Product/Process Change Notice (PCN)		
<input type="checkbox"/> Major Change <input checked="" type="checkbox"/> Minor Change		
PCN Number: PCN_FrqSPXO_20250112 Affected Series: WE-SPXO Affected Part Number: 830206385009, 830208229109, 830207390509, 830208229409, 830200968609 PCN Date: 2024-11-12 (YYYY-MM-DD) Effective Date: 2025-02-12 (YYYY-MM-DD)	Change Category: <input type="checkbox"/> Equipment/Location <input checked="" type="checkbox"/> General Data <input type="checkbox"/> Material <input type="checkbox"/> Process <input type="checkbox"/> Product Design <input type="checkbox"/> Shipping/Packaging <input type="checkbox"/> Supplier <input type="checkbox"/> Software	
Contact: Product Management Phone: +49 (0) 7942 - 945 5001 Fax: +49 (0) 7942 - 945 5179 E-Mail: pcn.eisos@we-online.com	Datasheet Change: <input checked="" type="checkbox"/> Yes <input type="checkbox"/> No Attachment: <input type="checkbox"/> Yes <input checked="" type="checkbox"/> No

DESCRIPTION OF CHANGE: Because of a database mismatch, Würth Elektronik eiSos will correct the RoHs status (1), packaging details (2), product dimensions (3) and IQD Part No. format (4) in the datasheet. This is a datasheet correctio

3. Correction of the Product Dimensions:

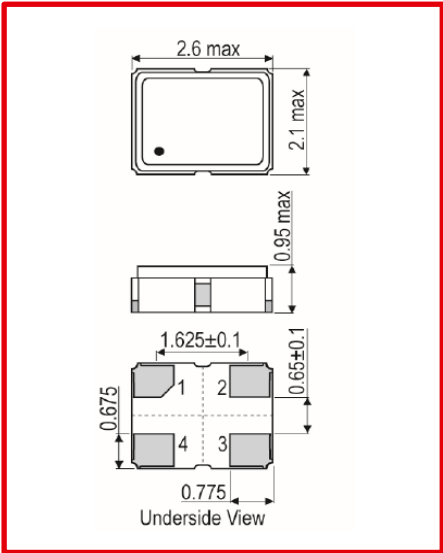
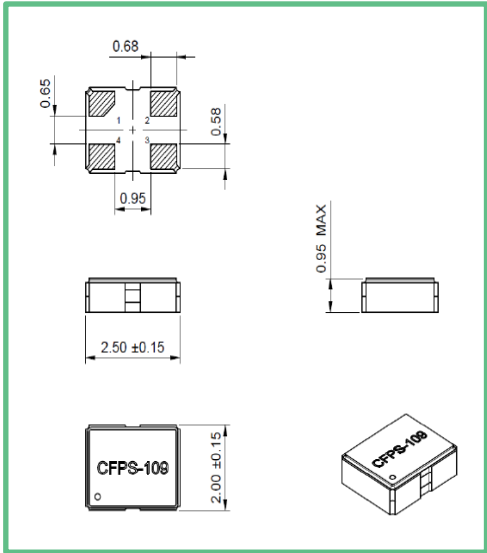
Before	After
Product Dimensions		
L	2.6 max	2.5 ± 0.15
W	2.1 max	2.0 ± 0.15
H	0.95 max	0.95 max
